The logo for URBIS, consisting of the word "URBIS" in a bold, white, sans-serif font, enclosed within a white square frame.

# 35-45 LITHGOW STREET, ABBOTSFORD

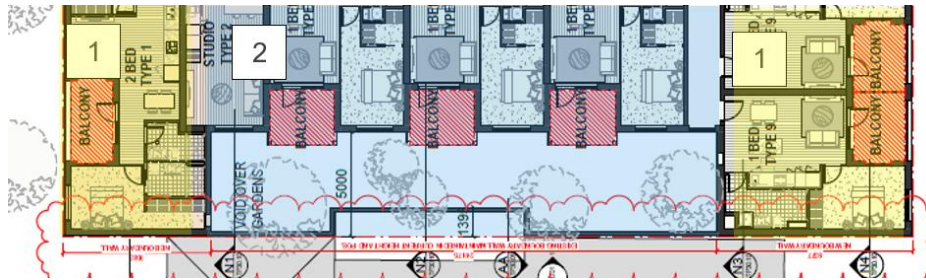
Figure 33 Mark-up of northern boundary interface at lower levels
